Minimum Safety Distance to the front

ACSF IWG 20th meeting
November 2018, Liverpool

Korea Automobile Testing & Research Institute

● Comment from 19th session

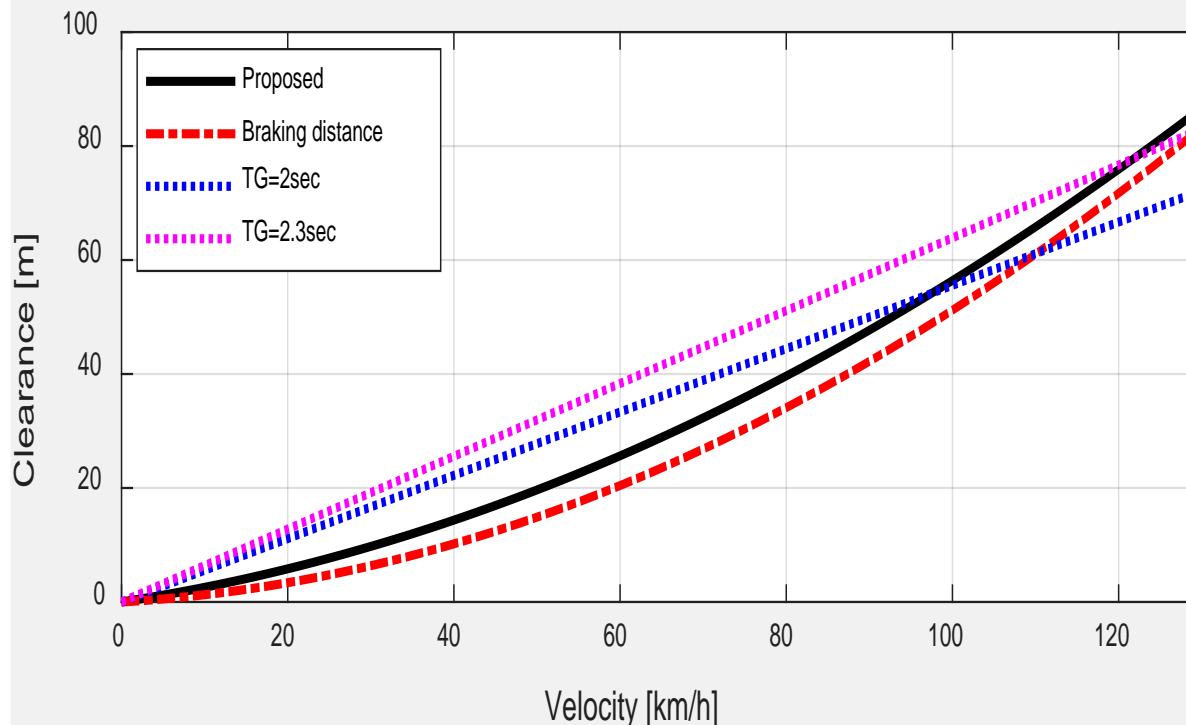
- Concern for frequent occurrence of cutting-in vehicle in front of the activated vehicle with too long clearance in low speed range (traffic jam situation) due to a fixed time gap

- **New approach for time gap increased linearly by vehicle speed**

- Fixed time gap to variable time gap by vehicle speed

(starting time gap 0.8 at 0 km/h and ending 2.4 at 130km/h)
